ADDENDUM NUMBER ONE

DATE OF ISSUANCE: August 16, 2019 **PROJECT NUMBER:** 19028

PROJECT: Snowbasin Clinic
3925 Snow Basin Road
Huntsville, Utah 84317 **ARCHITECT:** JRCA Architects, Inc.
577 South 200 East
Salt Lake City, Utah 84111

MECHANICAL ADDENDUM 1

1 LEVEL 1 HVAC PLAN
EP111 1/4" = 1'-0"

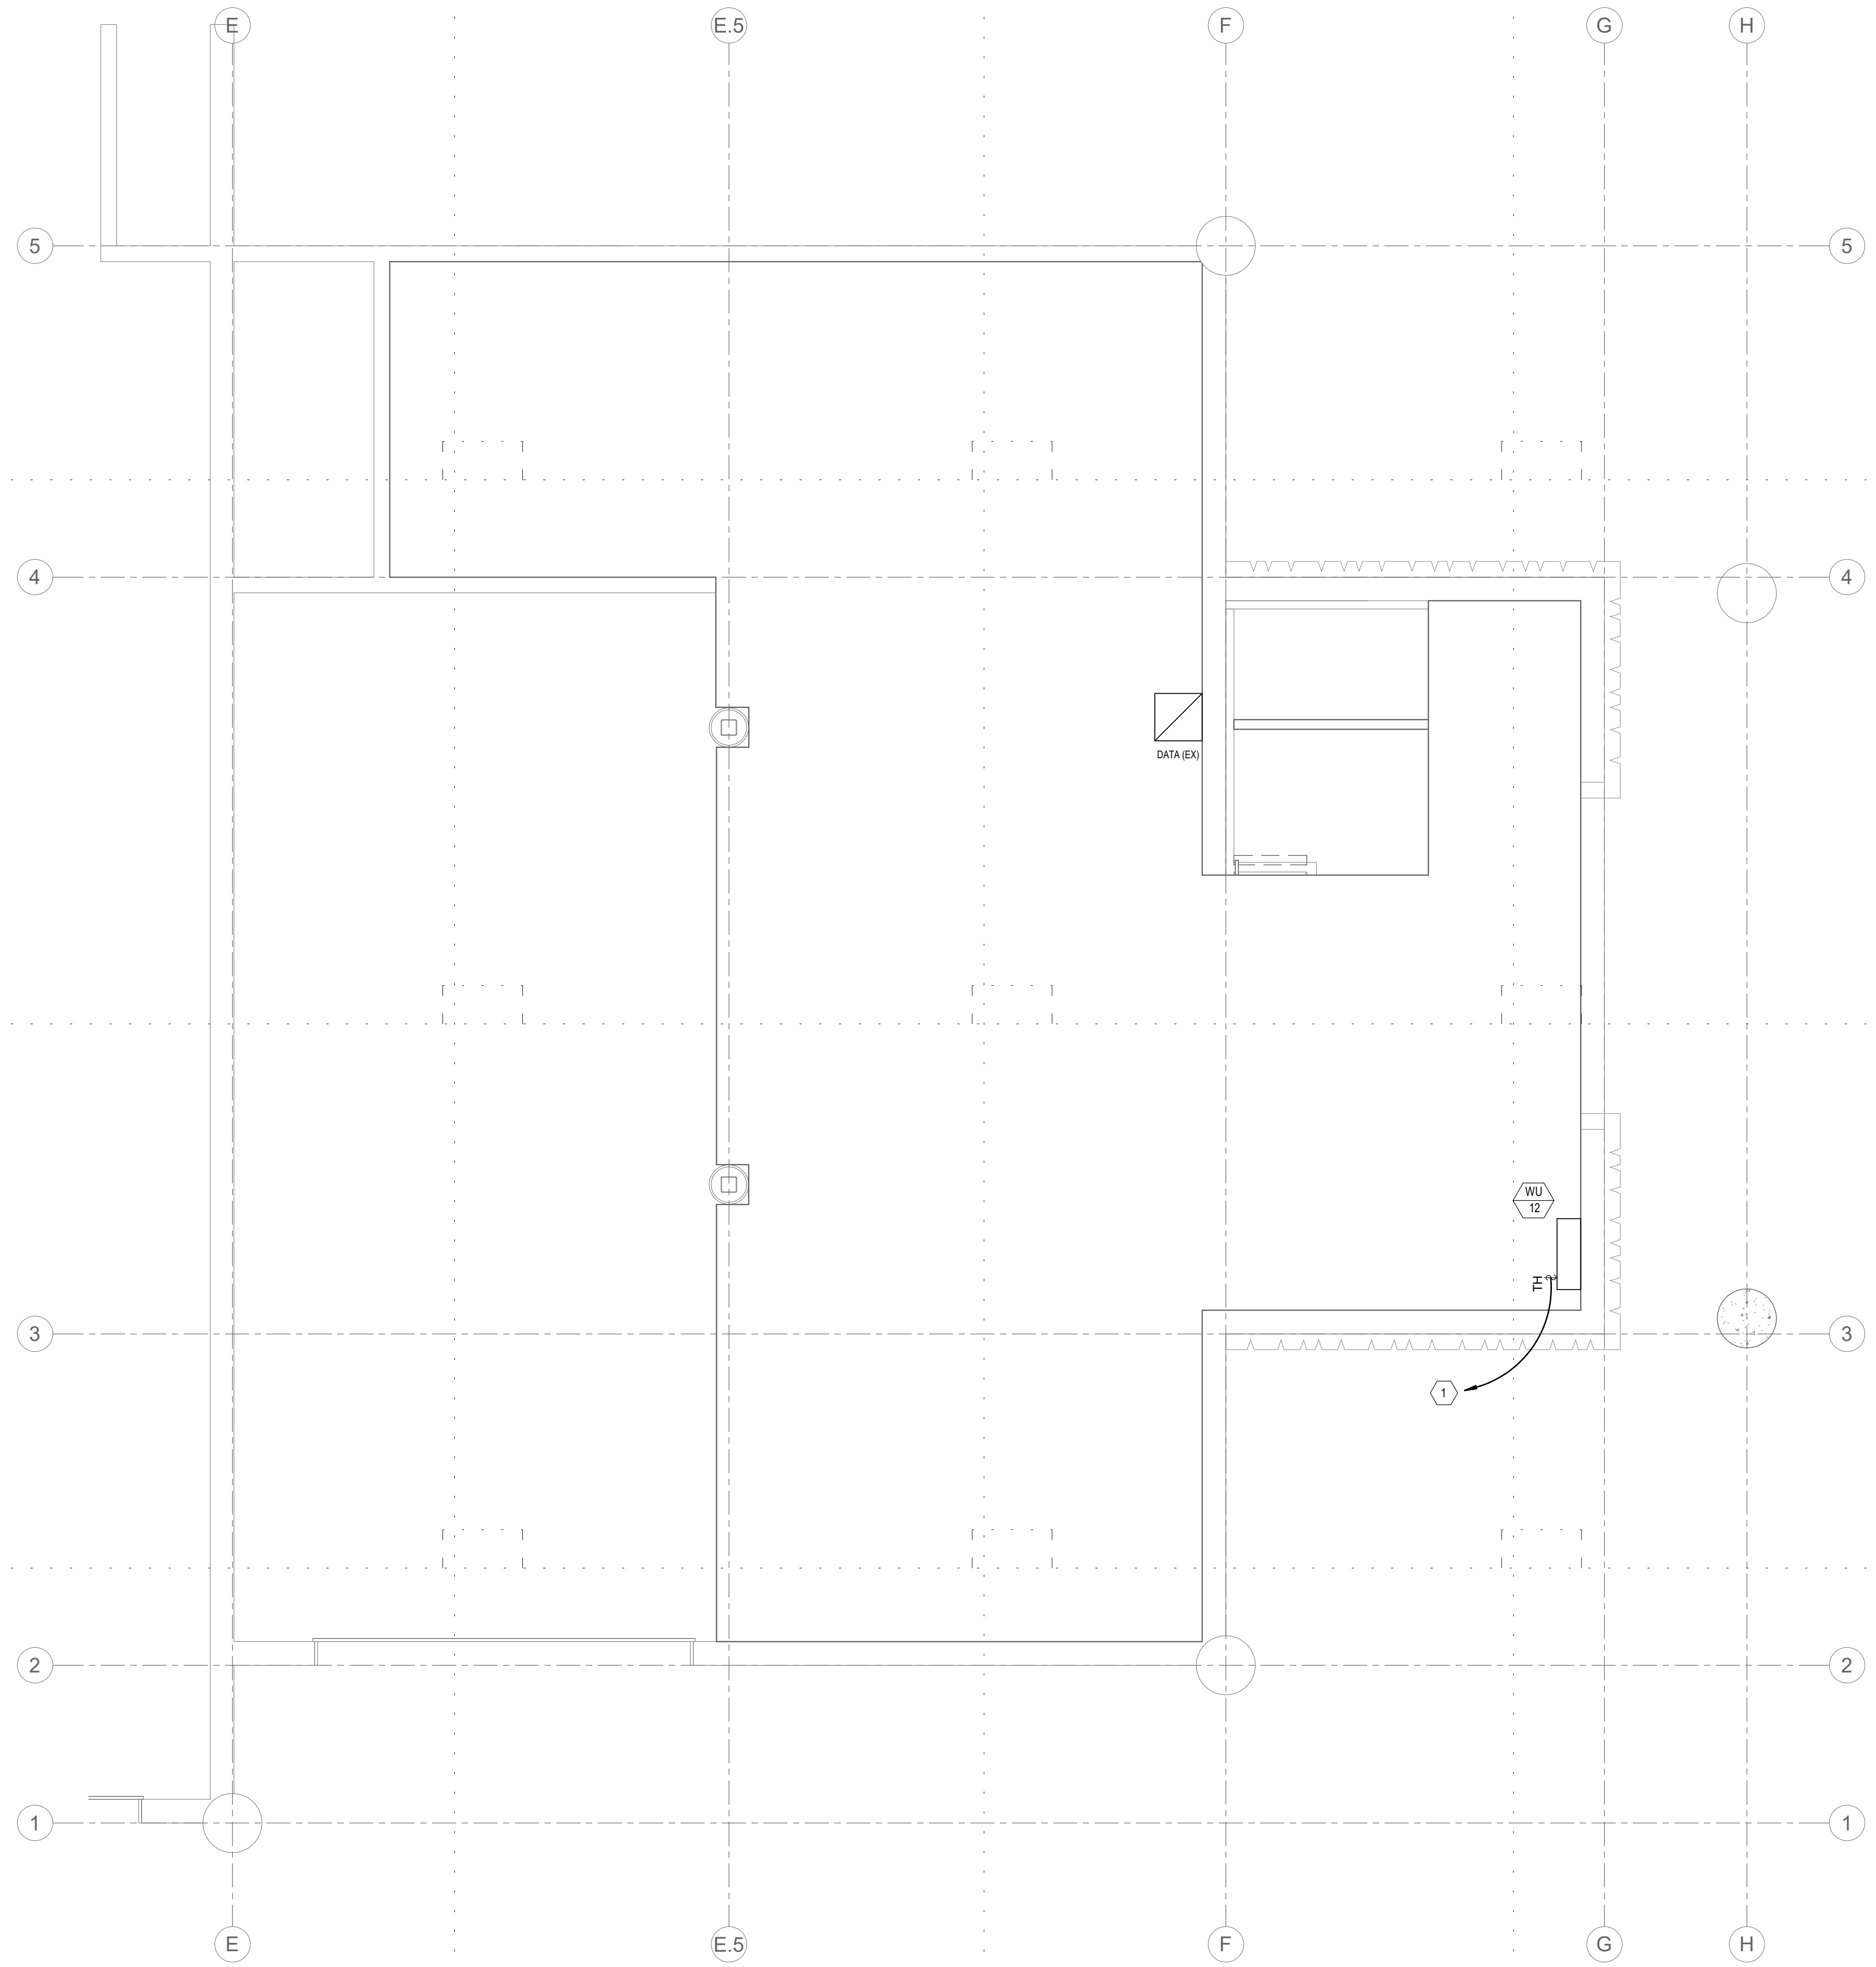
1. Revised entire sheet.

1 LEVEL 1 SYSTEMS PLAN
EY101 1/4" = 1'-0"

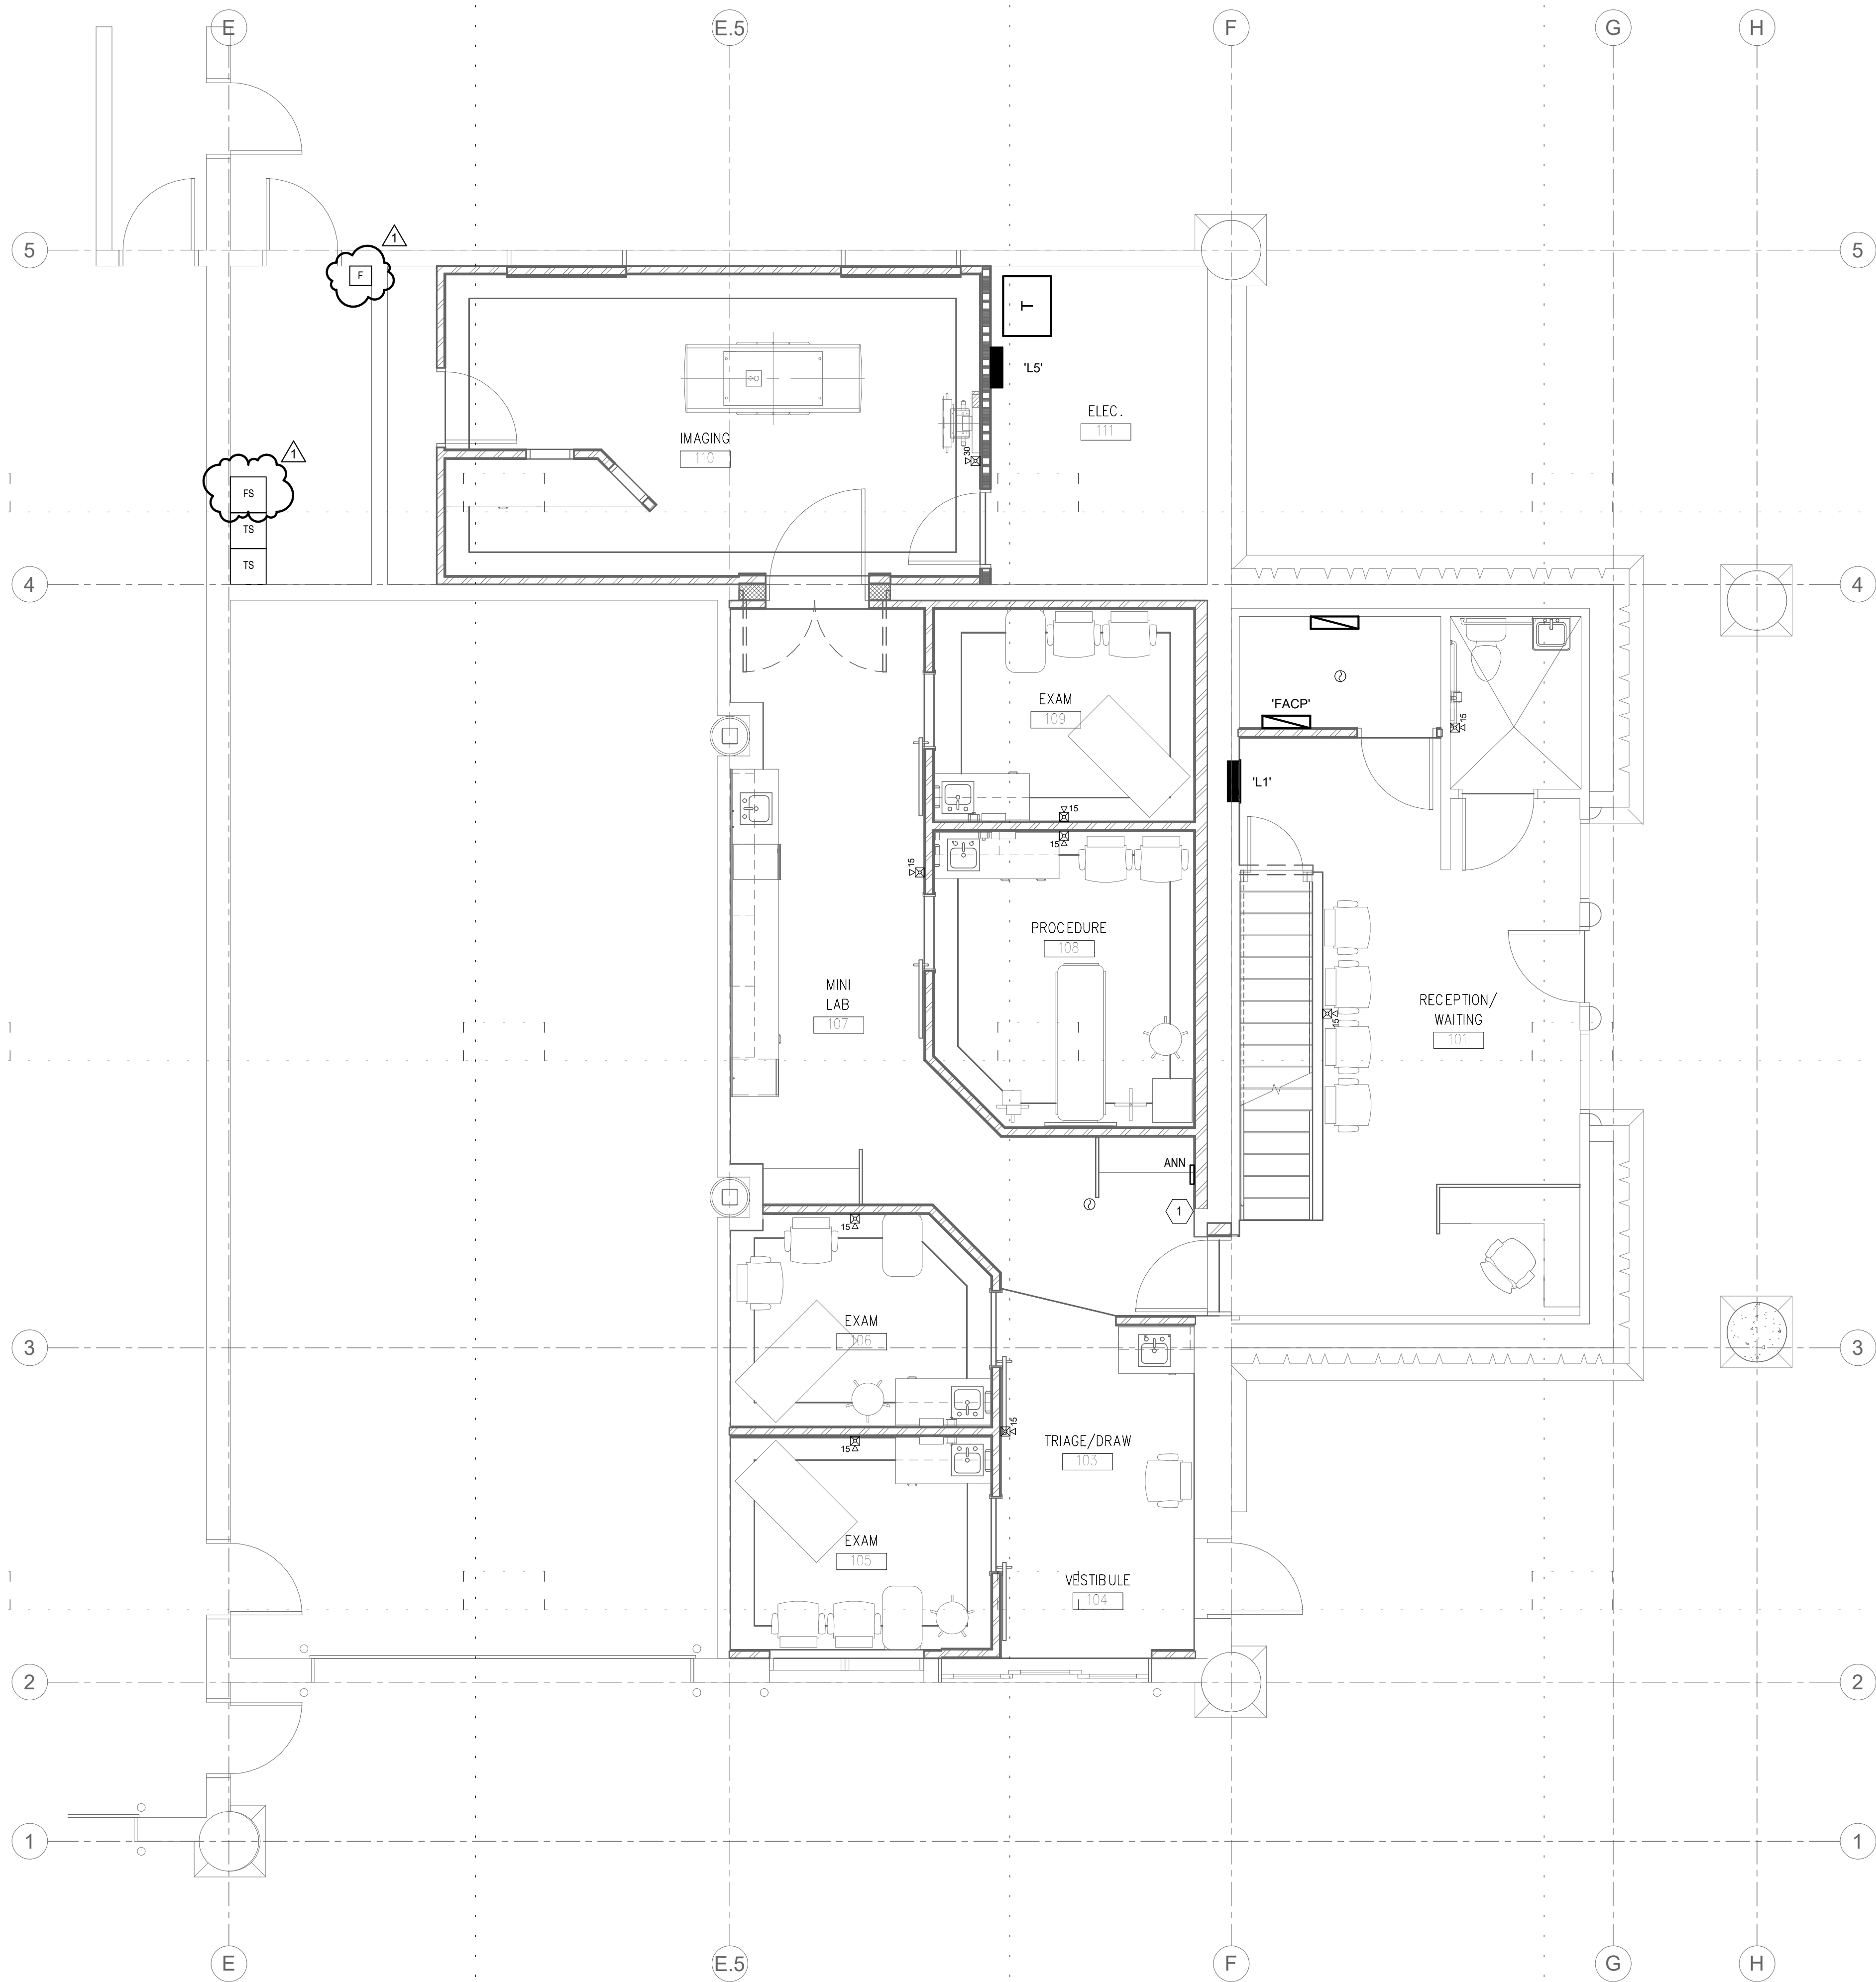
1. Add fire alarm pull station and flow switch in fire riser room.

1 ONE-LINE DIAGRAM
EE601 NO SCALE

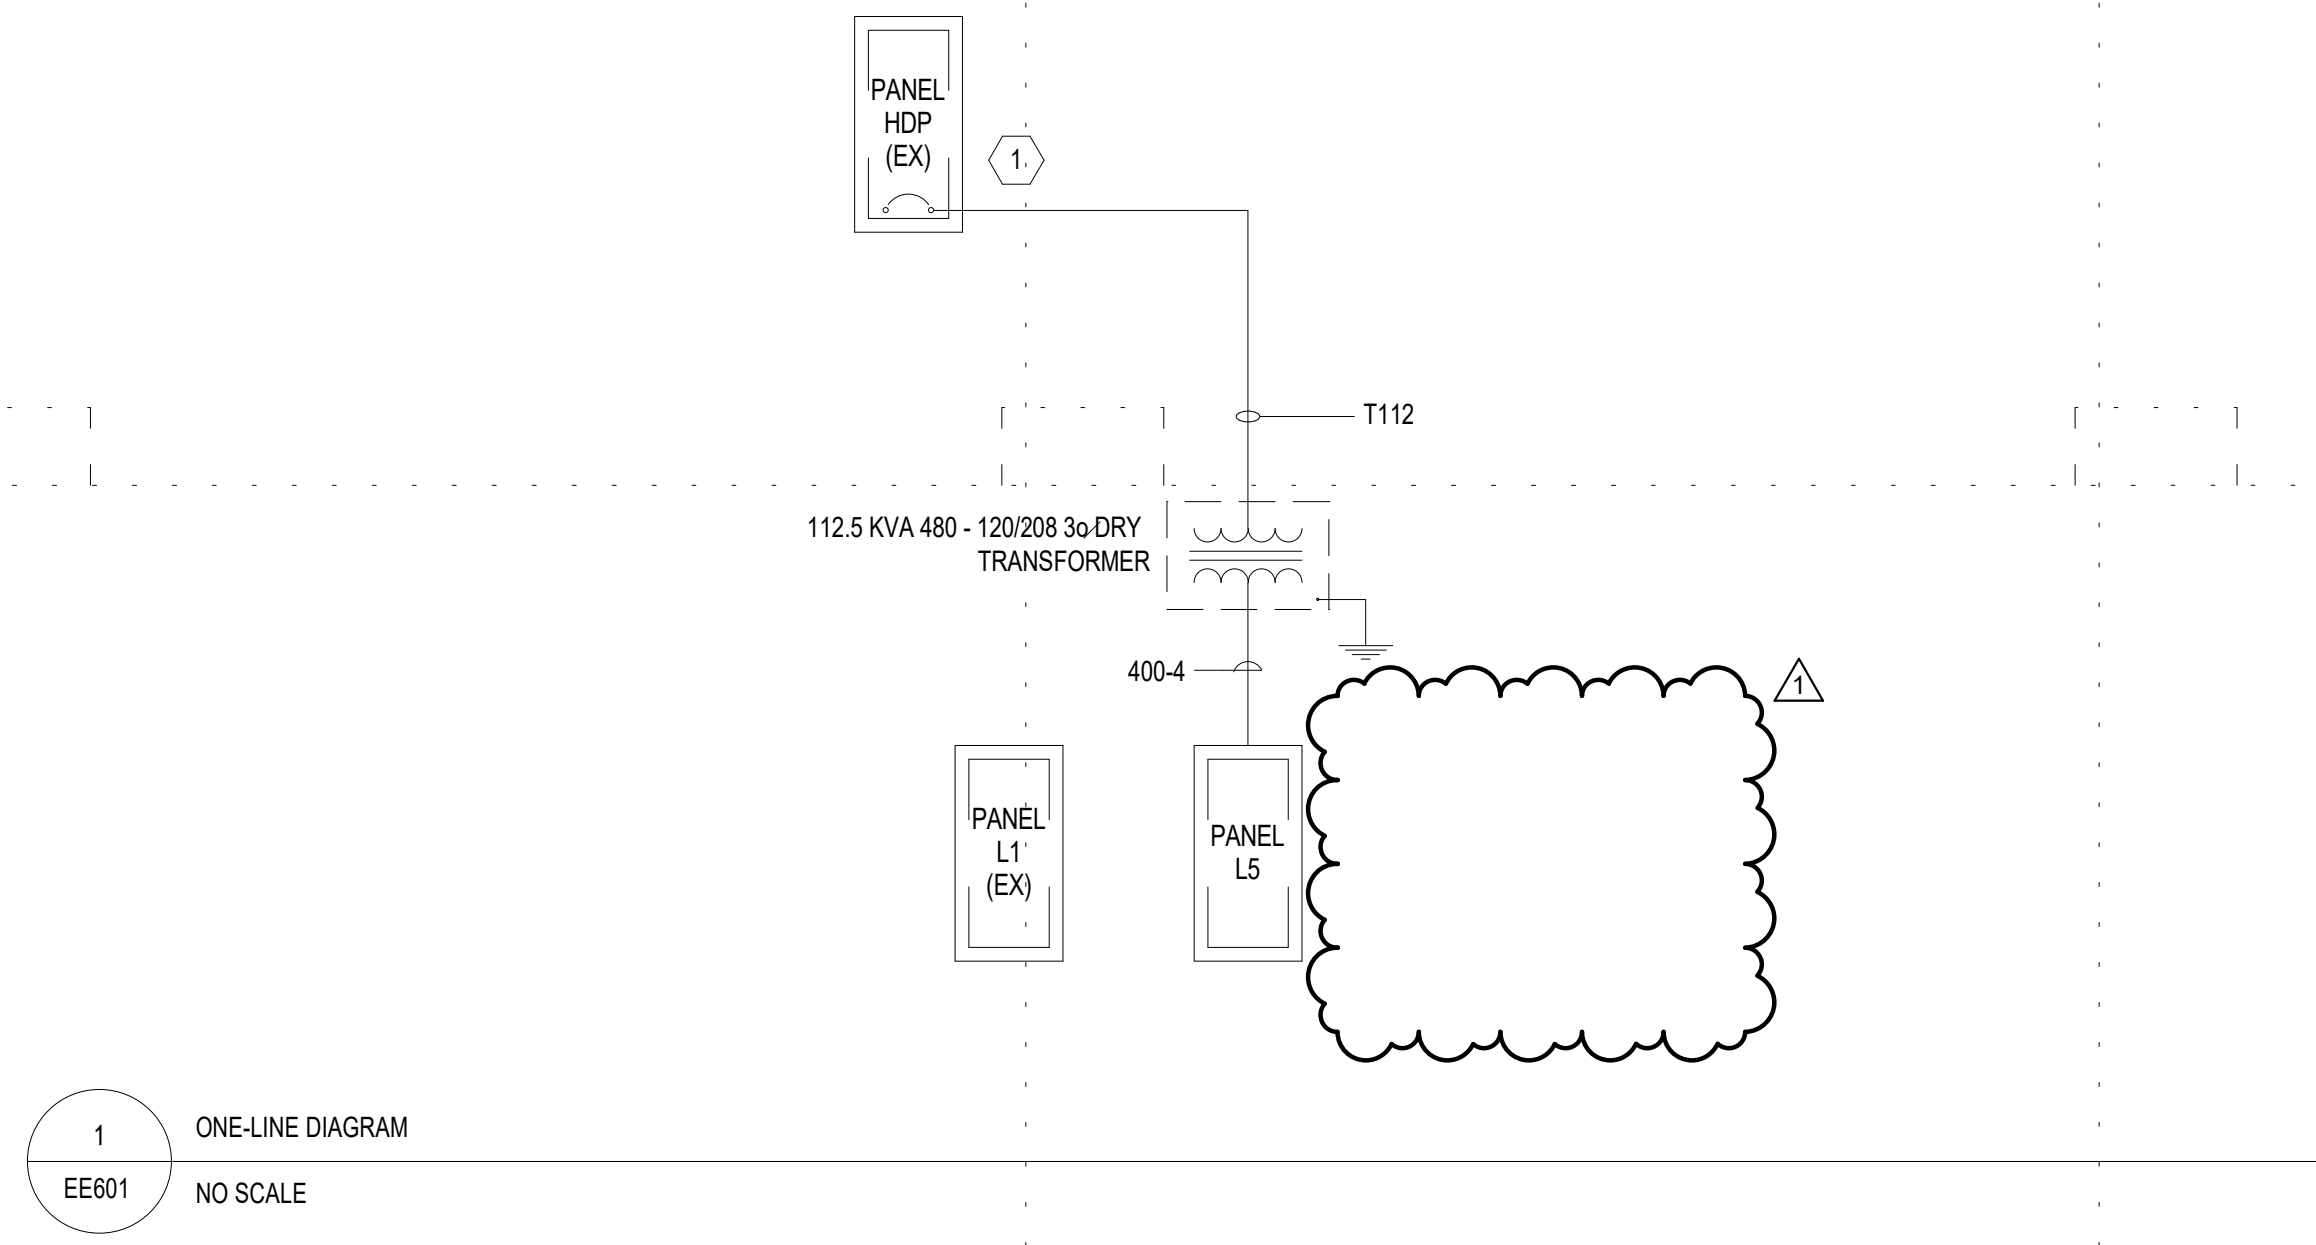
1. Delete Panel L6.
